# CONCEPT PLAN REVIEW: LULLWATER, ADAIR ROAD (OLD UNIVERSITY STATION ROAD EXTENSION) (PROJECT #21-053)

## SUMMARY REPORT

<b>PROPERTY ADDRESS</b> Adair Drive (Old University Station Road Extension)	<b>MEETING DATE</b> September, 14 2021	<b>APPLICANT</b> CJT, PA, on behalf of NGI Acquisitions, LLC
<b>STAFF RECOMMENDATION</b> That the Housing Advisory Board transmit comments to the applicant regarding the proposed development.		
<b>PROCESS</b> <ul style="list-style-type: none"><li>• The Housing Advisory Board has the opportunity tonight to hear the applicant’s presentation, hear public comments, and offer suggestions to the applicant.</li><li>• The Housing Advisory Board’s comments will also be transmitted to the Town Council for review at the September 22, 2021 meeting.</li><li>• The Community Design Commission reviewed a concept plan for this site on August 24, 2021.</li><li>• The Stormwater Utility Management Advisory Board reviewed a concept plan for this site on August 24, 2021.</li></ul>	<b>DECISION POINTS</b> <ul style="list-style-type: none"><li>• The site is located in the North MLK Future Focus Area of the FLUM.</li><li>• Consideration of building placement, design and art

## Future Land Use Map (Excerpt)

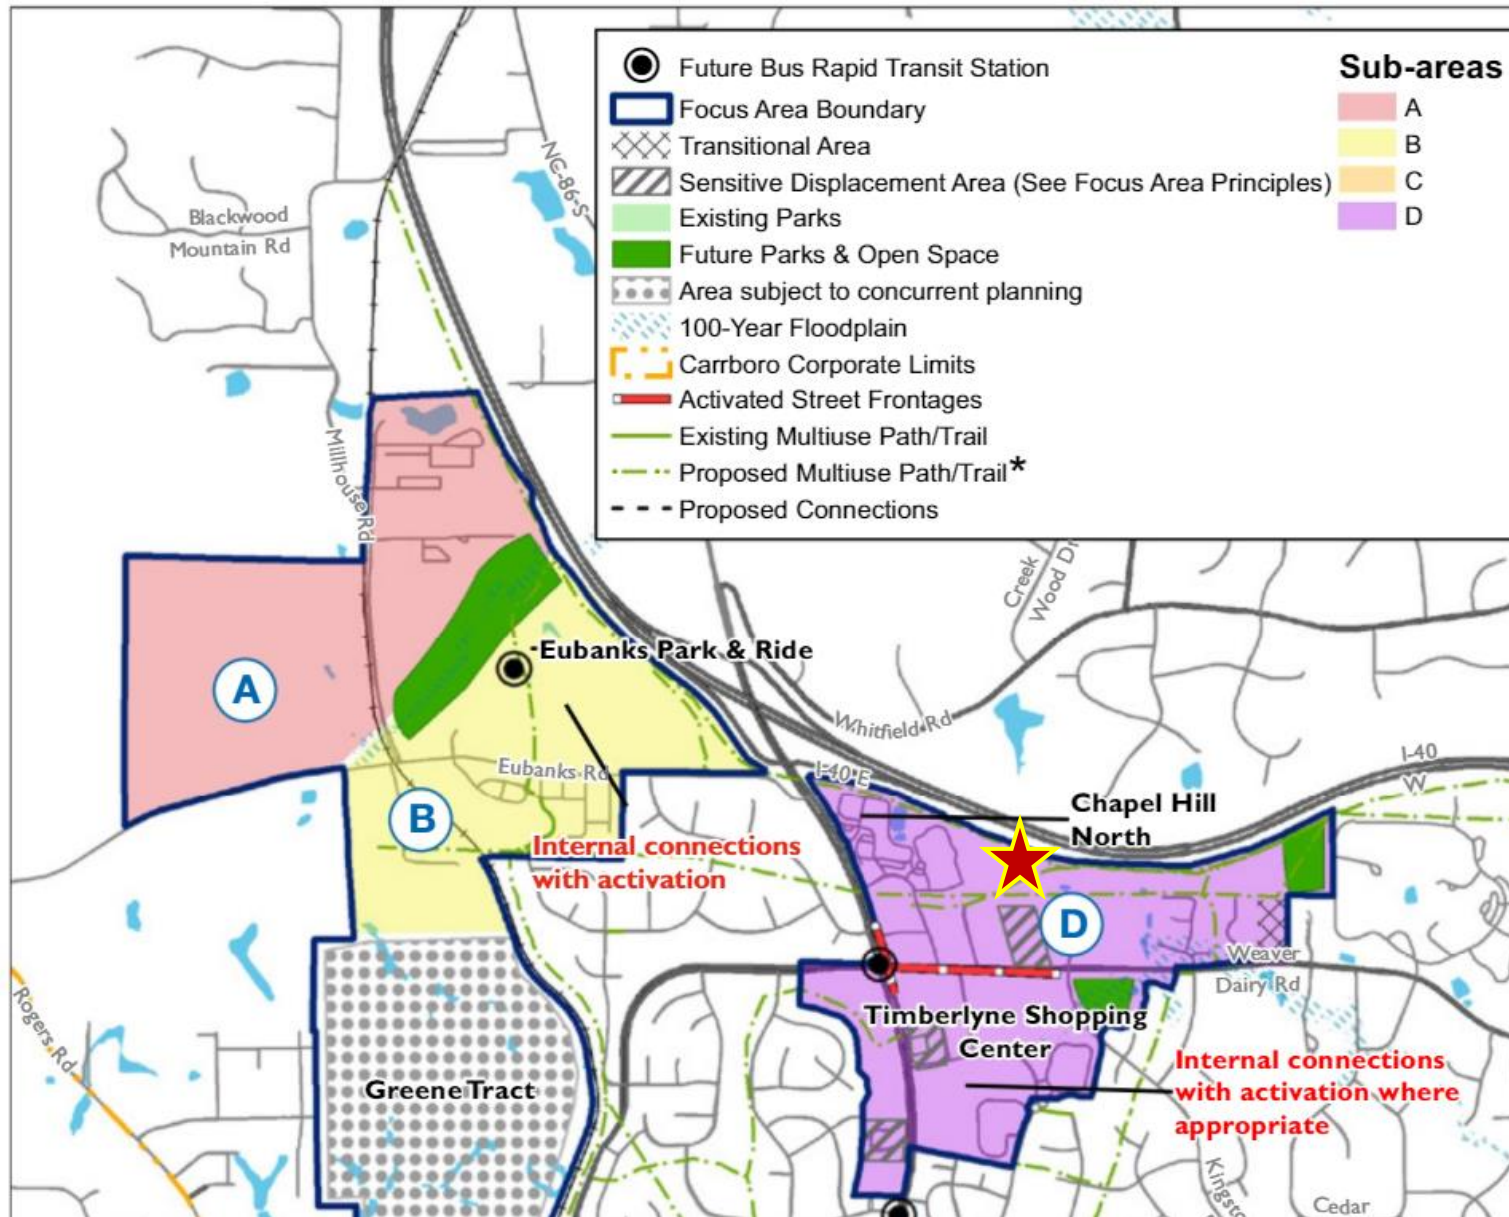
- The project is located in the N MLK Jr Blvd Focus Area, Sub-Area D.
- Multifamily Residential is identified as one of the appropriate Primary land uses.
- Typical Height in the Sub-Area is 4-6 stories.
- No features are shown for Transitional Area, Activated Street Frontages, Proposed Connections, or Future Parks & Open Space impacting the site.
- The Mobile Home Park to the south is identified as a Sensitive Displacement Area.

## Mobility and Connectivity Plan (Excerpt)

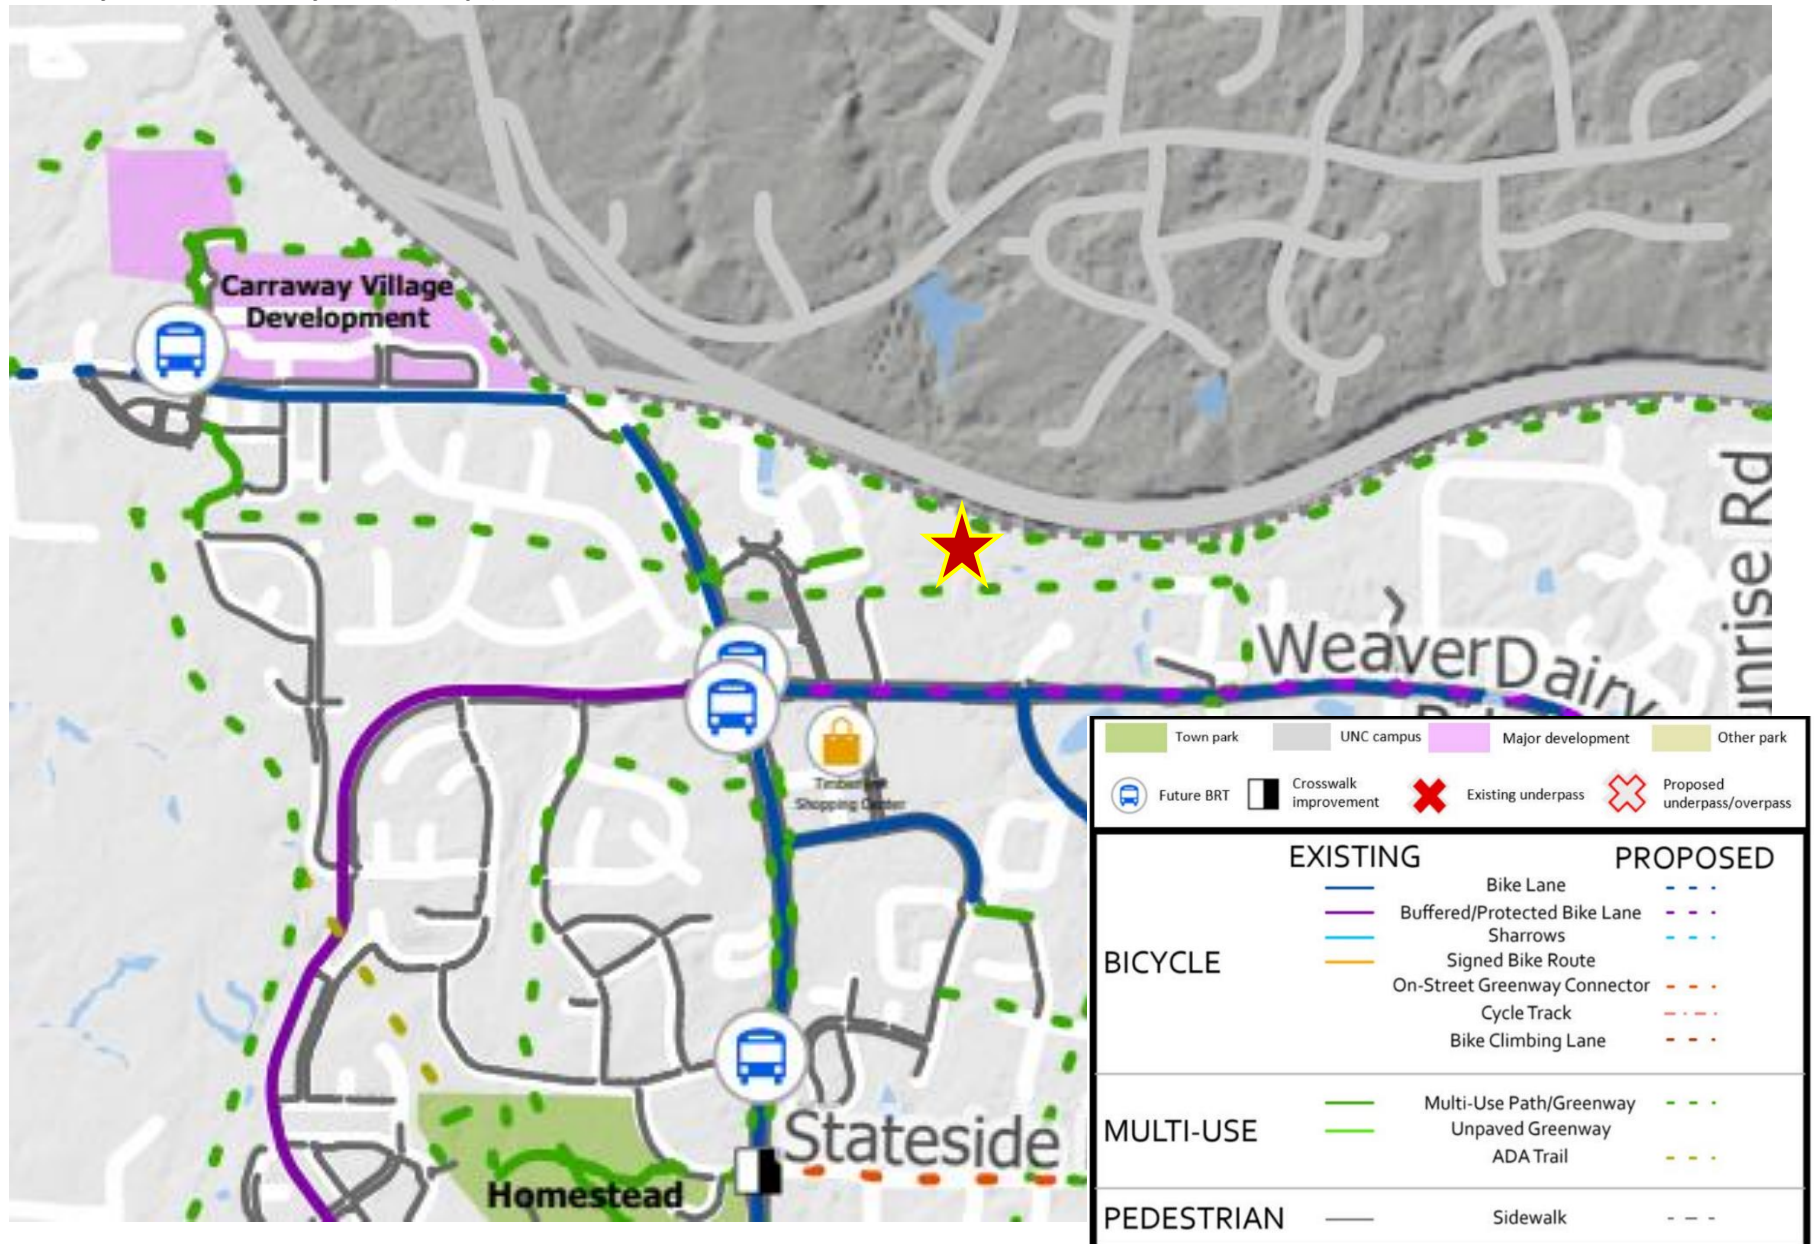
- The site does not front on existing roads. Proposed extensions of Adair Drive and Old University Station Road would provide access to the site.
- Two greenways proposed on the Mobility Plan impact the site, running east-west. One would run along or near the southern property line, within the power easement. The second would run along or near I-40 and the northern property line.
- A future *Bus Rapid Transit station* is located within ¼ mile of the site. The applicant should **coordinate with Chapel Hill Transit** for the latest information on BRT design, station locations and any potential connections.

## Parks Comprehensive Plan (Excerpt)

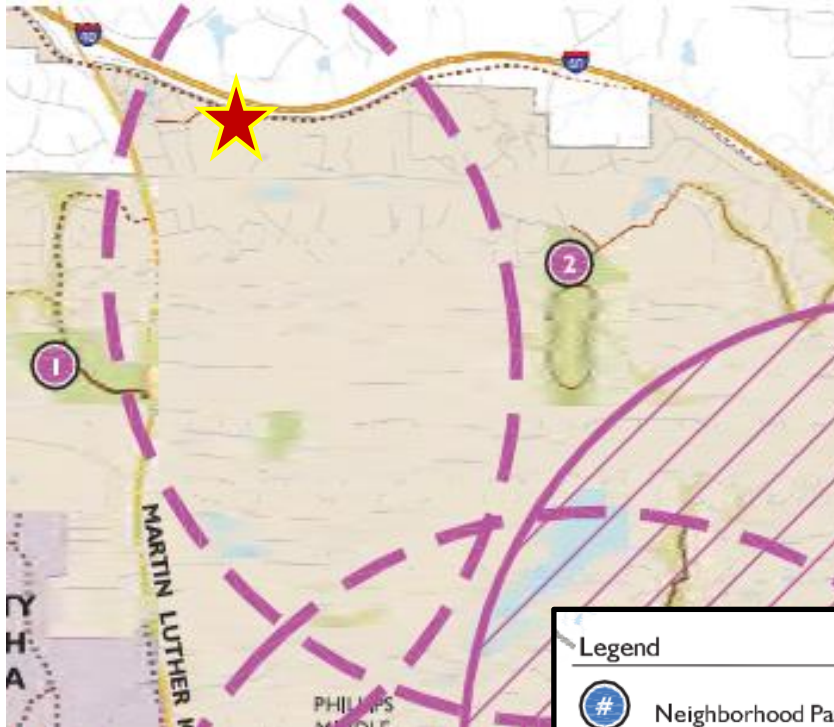
- The site falls within the Community Park Service Areas for Cedar Falls and Homestead Park. The site does not fall within a Neighborhood Park Service Area.
- No additional Neighborhood Parks or Community Parks are proposed in the vicinity of the site.
